MEMORANDUM (sent via email only)

SUBJECT: Passive Sub Slab Depressurization (SSD) System Operation and Maintenance Plan (Document Control Number [DCN] FY22SEMD_161) and Evaluation of Passive SSD System, Former TRW Microwave Site, Sunnyvale, California

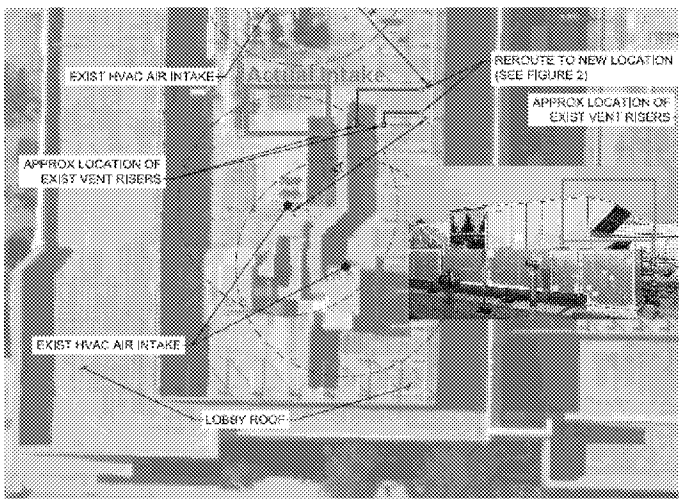
5. [SSD Evaluation; Vent height] The current height proposed does not appear to be sufficient to clear obstructions. Clearing obstructions is important for dispersion of pollutants and to provide sufficient exposure to wind (which provides part of the driving force for proper passive SSD operation).

6. [SSD Evaluation; Location of HVAC intakes] The HVAC intake location is mislabeled. Please correct this and verify that the other HVAC intakes were properly located.
